**MONTARA STATE BEACH**

**GENERAL PLAN AMENDMENT (\*)**

PROPOSED AMENDMENT TO GENERAL PLAN  
GRAY WHALE COVE AND MONTARA STATE BEACHES  
SAN MATEO COAST AREA

To change the location of proposed parking for public beach access.

FIGURE 36a

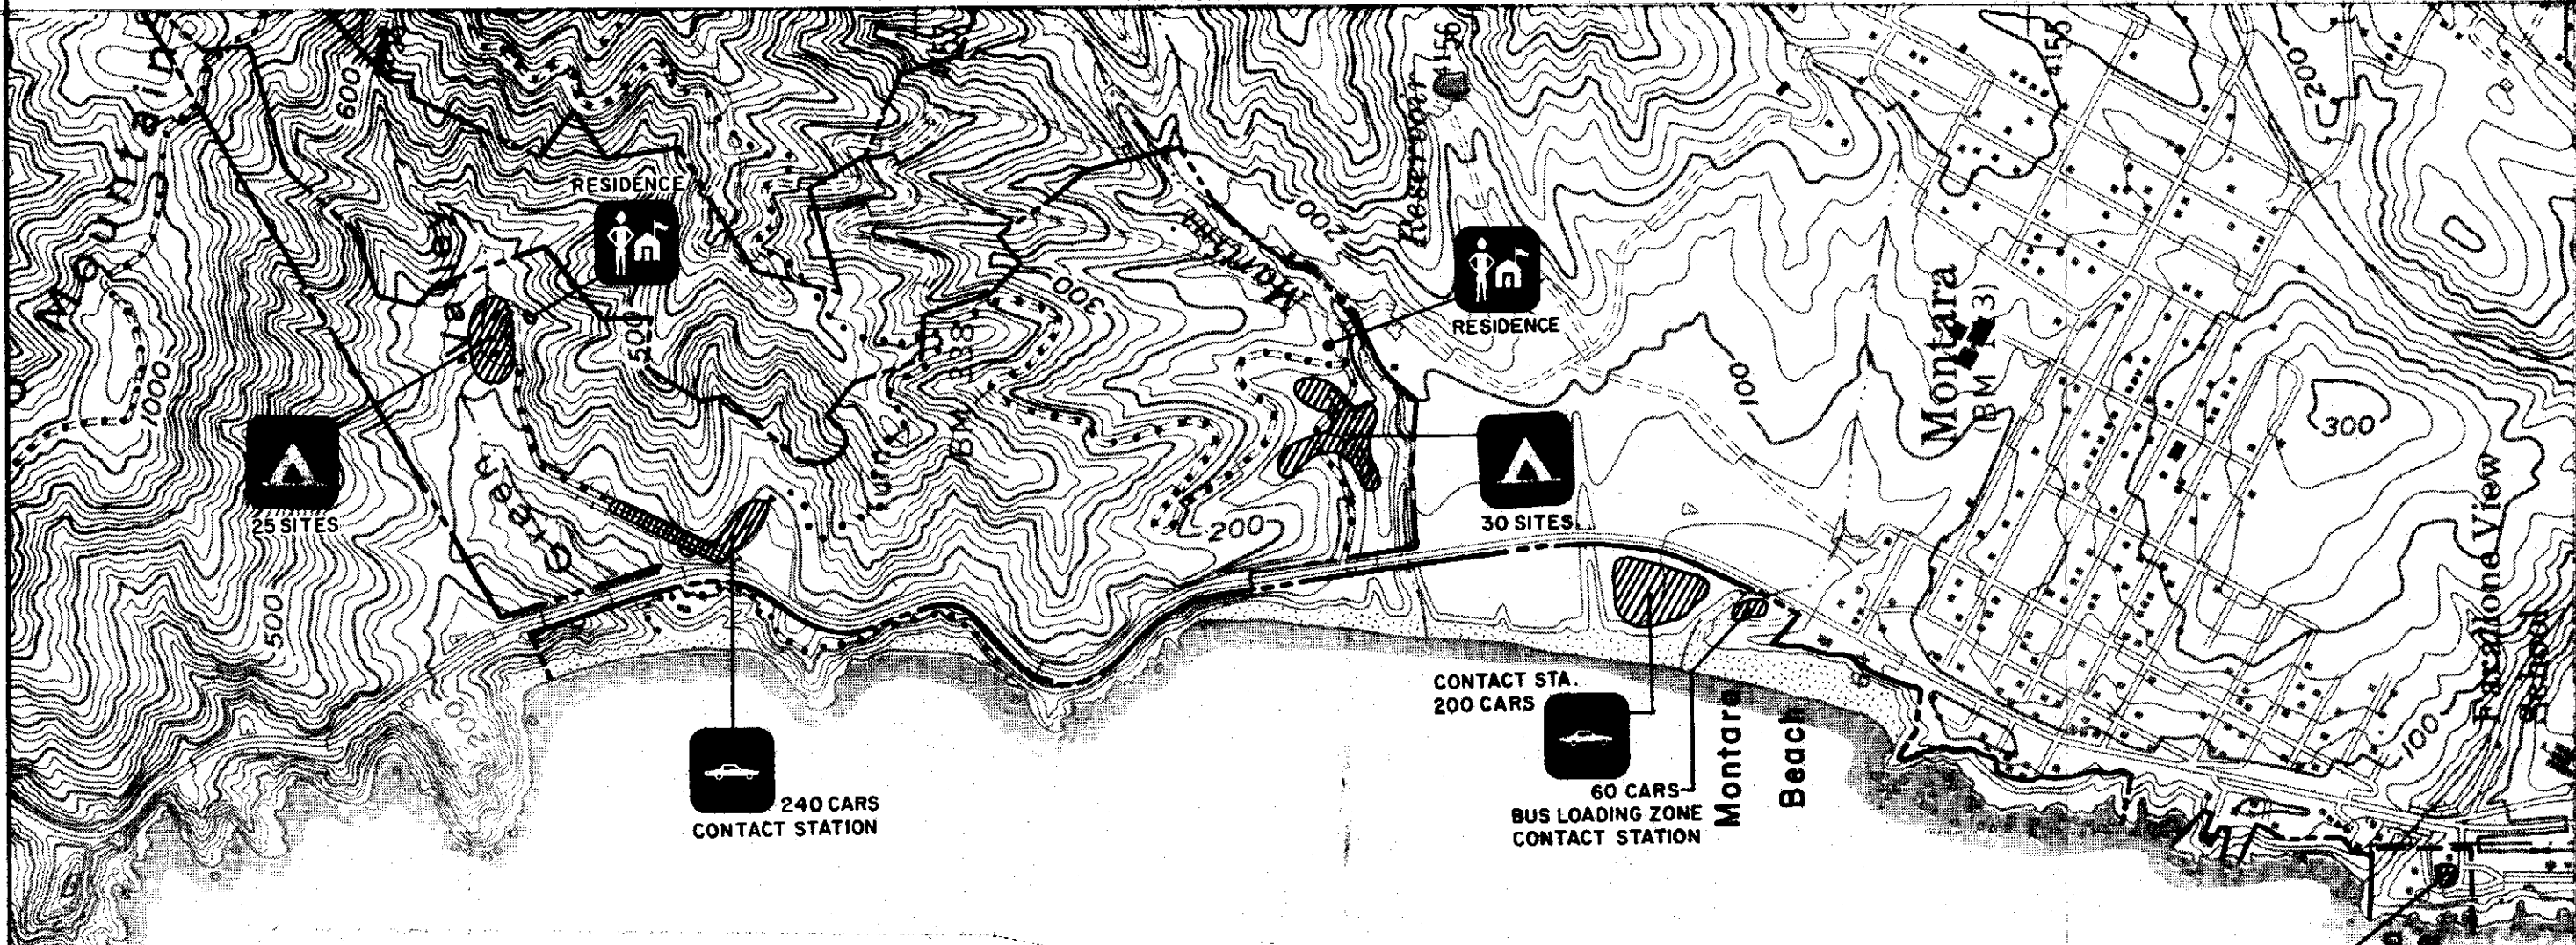
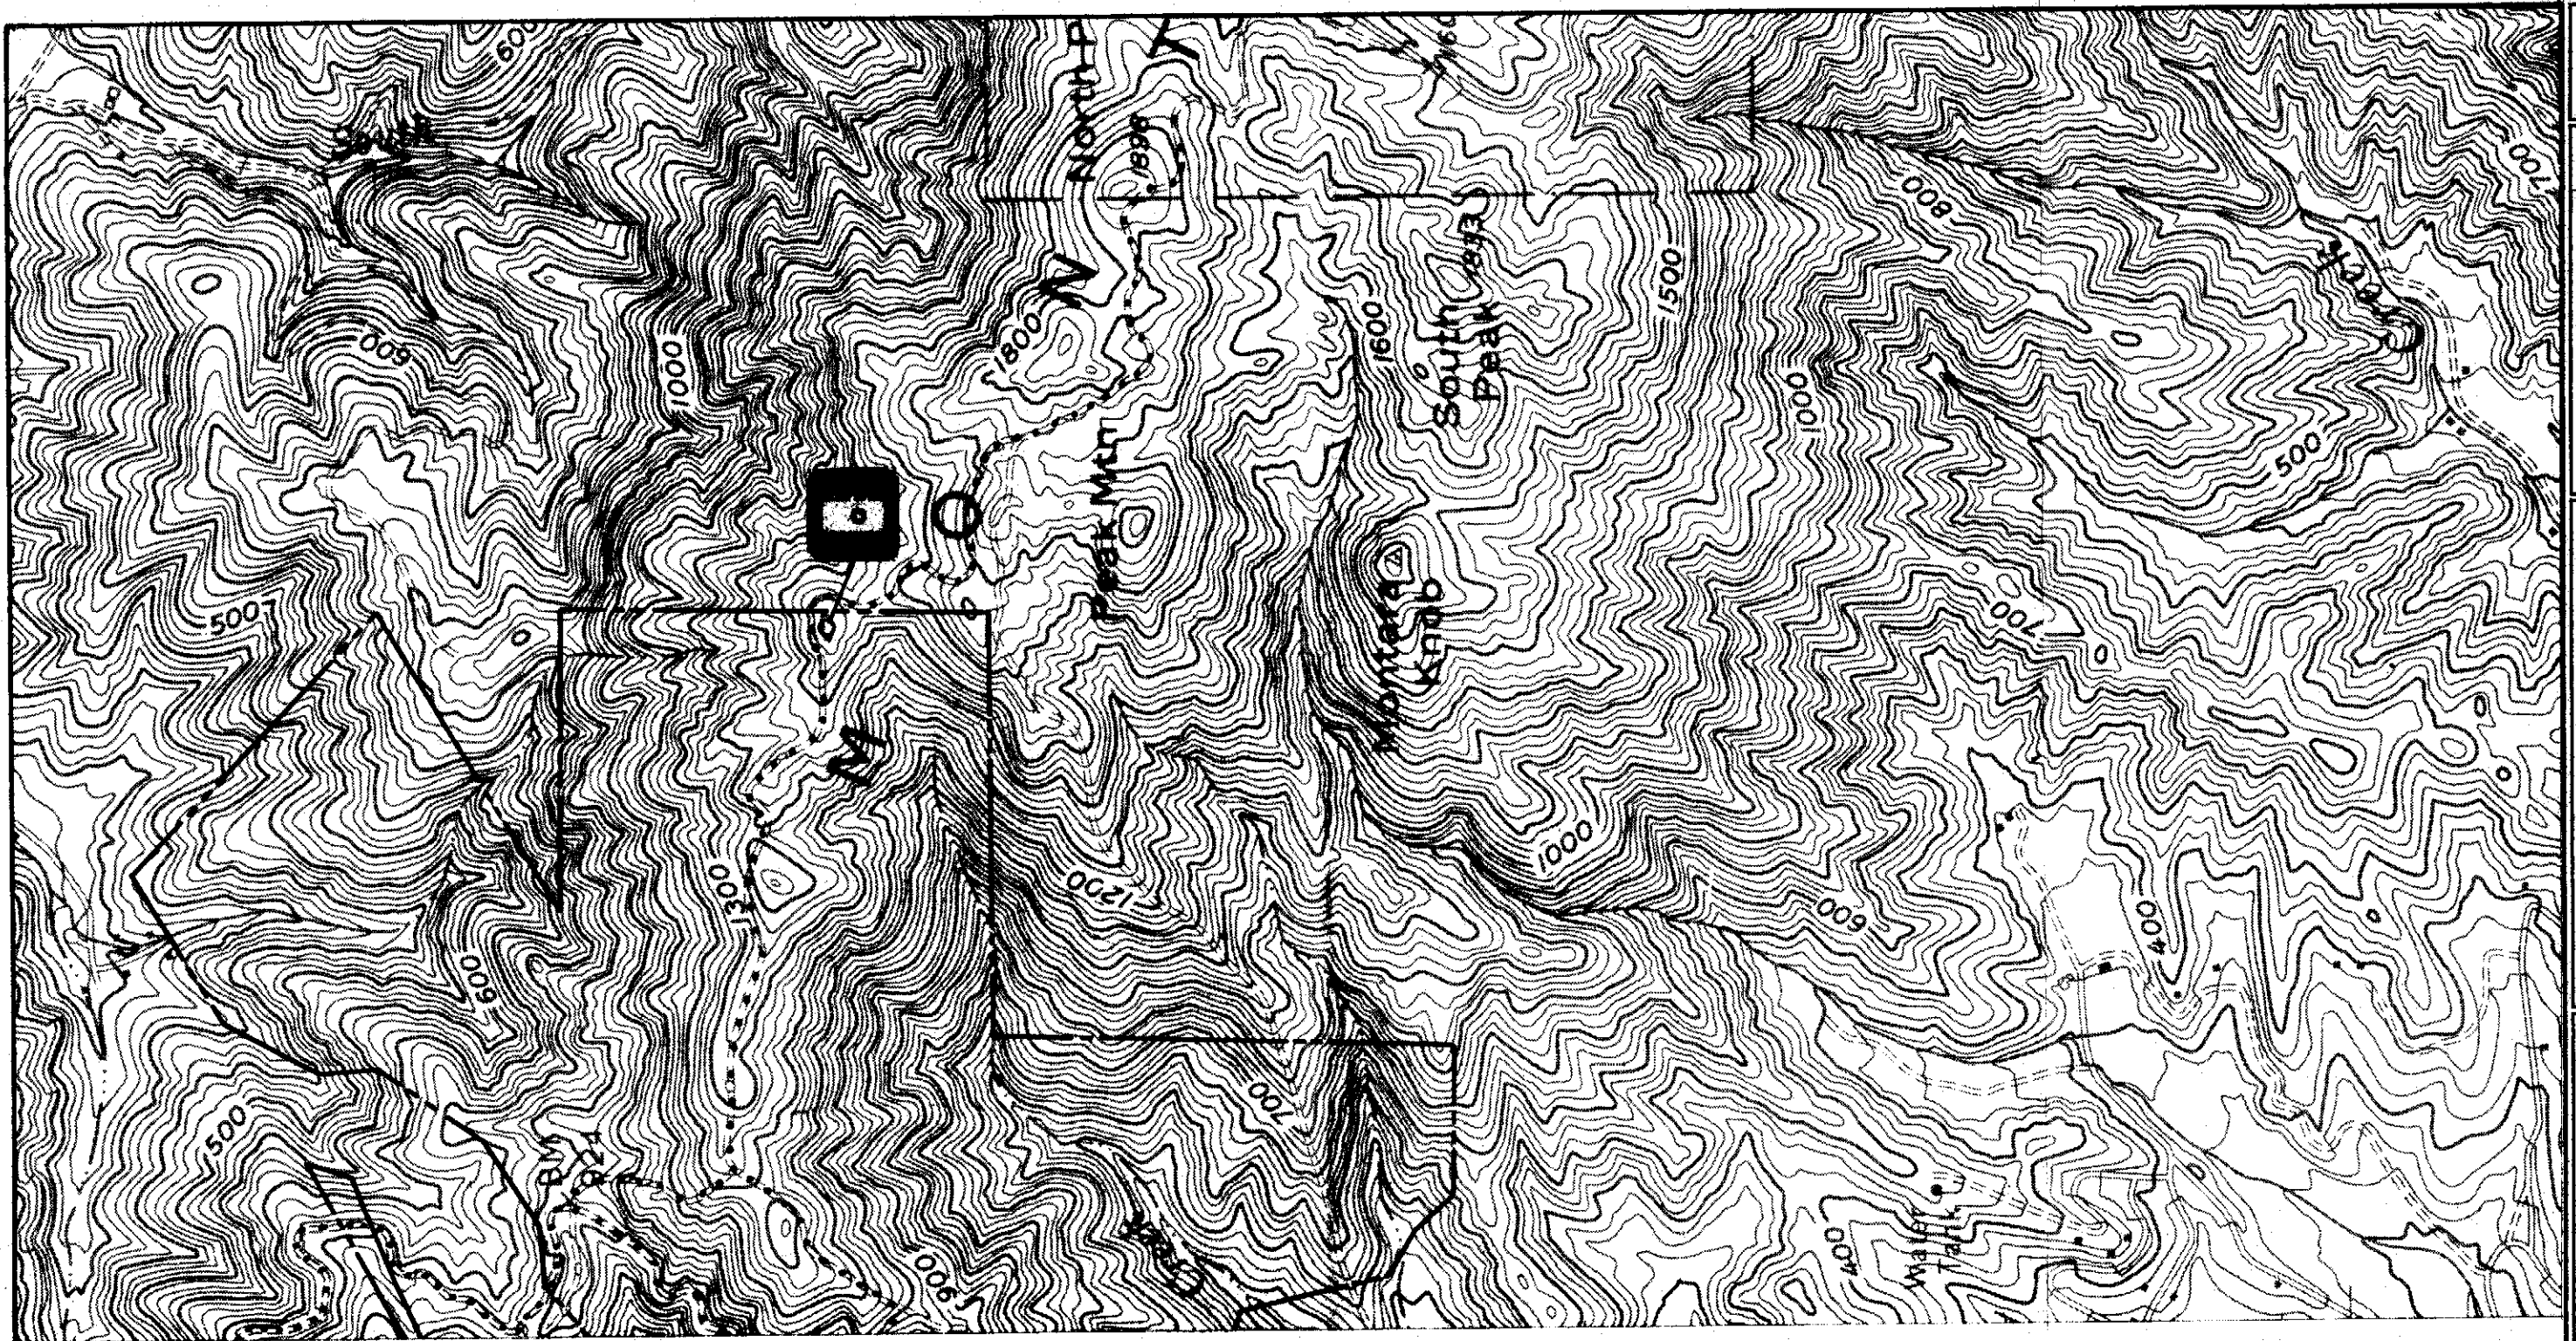
The storm of January 5, 1982 caused much damage along this area of the coast. Montara Creek washed out Highway 1 in the vicinity immediately adjacent to the proposed parking shown on the General Plan. Further research showed that the proposed parking site is made up of soft, loamy soil between two drainages, and is much more vulnerable to erosion than previously recognized. A pedestrian underpass or overpass would be required to safely provide public access to the beach from this proposed parking site, just inland of Highway 1.

Every possible alternative was investigated to find an area within the state beach boundary which would accommodate 200 cars without damage to cultural, natural, or scenic environments. There were no such areas. The site recommended by this amendment will cause the least disturbance to archeological values. It will not require grading and, being in a lower part of the mesa next to an existing restaurant development, it will be less intrusive on the open space scene immediately to the north. The recommended location also provides the best possible pedestrian access to the beach, because the bluffs are not as high as at all other possible locations.

- 1) Parking: develop 260-car parking, bus loading zone, restroom, and contact station on 4-acre site just north of Chart House Restaurant.
-
